CAUI-4 Ad hoc

Ryan Latchman, MACOM

Agenda

- Host stress updated figure

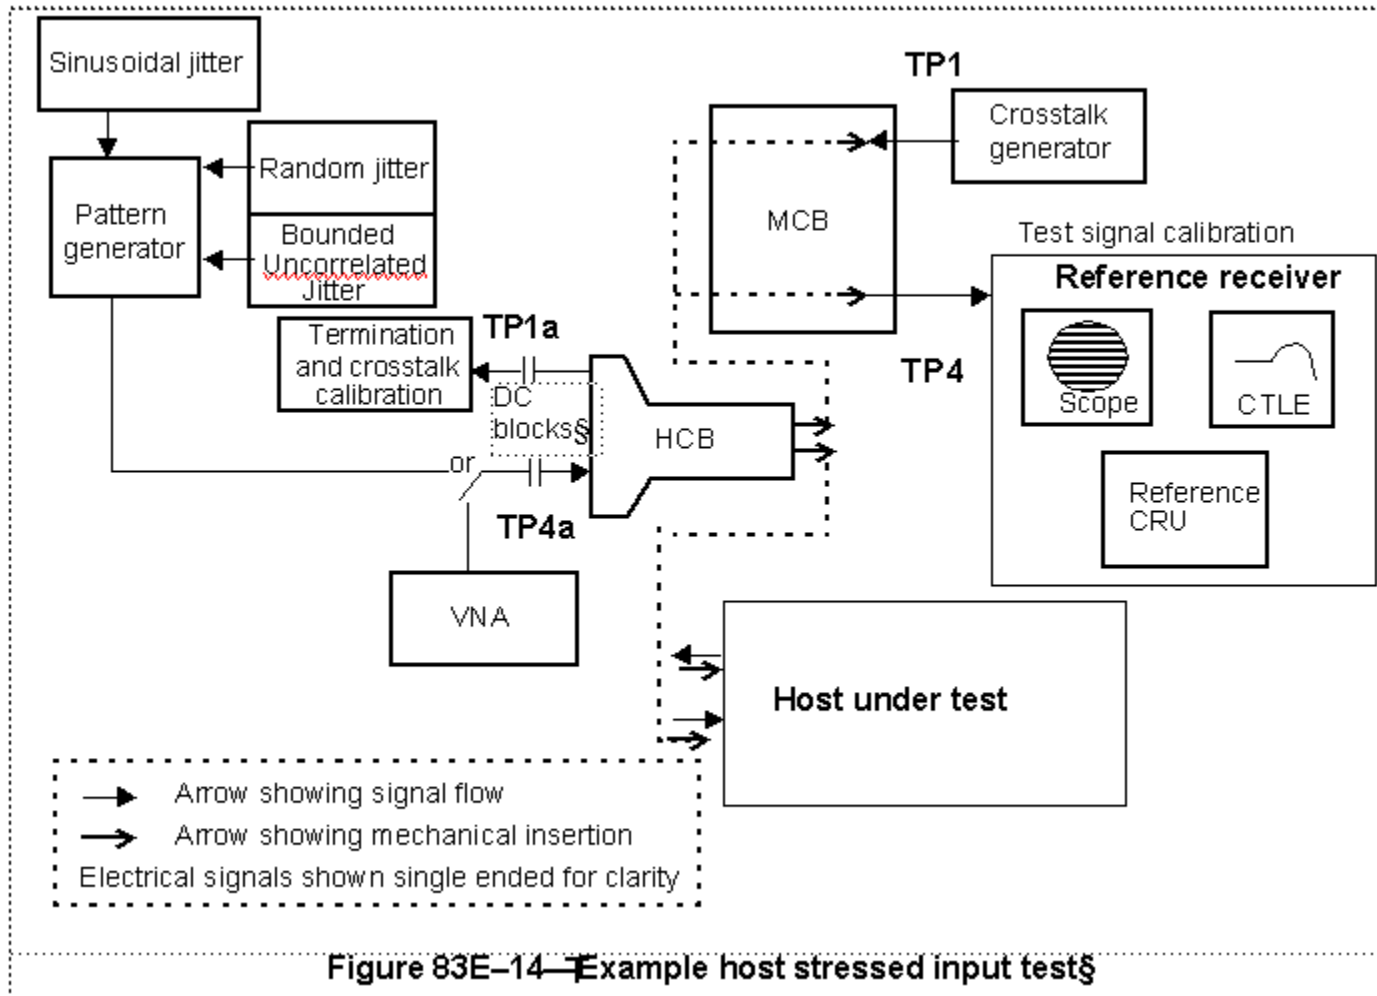
- Host stress text modification

83E.3.3.3.1 Host stressed input test procedure¶

The host stressed input test is summarized in Figure 83E-14. The stress signal is applied at TP4a, and is calibrated at TP4. A reference CRU with a corner frequency of 10 MHz and slope of 20 dB/decade is used to calibrate the stress signal using Pattern 4 (PRBS9) as defined in Table 86-11. The reference receiver includes a selectable software CTLE given by Equation (83E-4) and the first two rows of Table 83E-2. The stressed signal is generated by adding sinusoidal jitter, random jitter, and bounded uncorrelated jitter to a clean pattern. The amount of applied peak-to-peak sinusoidal jitter used for the host stressed input test is given in Table 83E-5. Bounded uncorrelated jitter provides a source of bounded high probability jitter uncorrelated with the signal stream. This jitter stress source may not be present in all stressed pattern generators or bit error rate testers. It can be generated by driving the pattern generator external jitter modulation input with a filtered PRBS pattern. The PRBS pattern length should be between PRBS7 and PRBS11. The data rate should be approximately 1/10th of the stressed pattern data rate (2.578 Gbd). The clock source for the PRBS generator is asynchronous to the pattern generator clock source to assure non-correlation of the jitter. The low pass filter that operates on the PRBS pattern to generate the bounded uncorrelated jitter should exhibit single pole roll-off with a -3dB knee between 150 MHz and 300 MHz. This value must also be below the upper frequency limit of the pattern generator external modulator input. Random jitter and bounded uncorrelated jitter is added such that the output of the pattern generator approximates a jitter profile given in Table 83E-6.¶

the product of eye height and eye width based on the eye measurement methodology given in 83E.4.2. Random jitter and the pattern generator output amplitude is adjusted to result in the eye height and eye width given in Table 83E-5 using the reference receiver. ¶
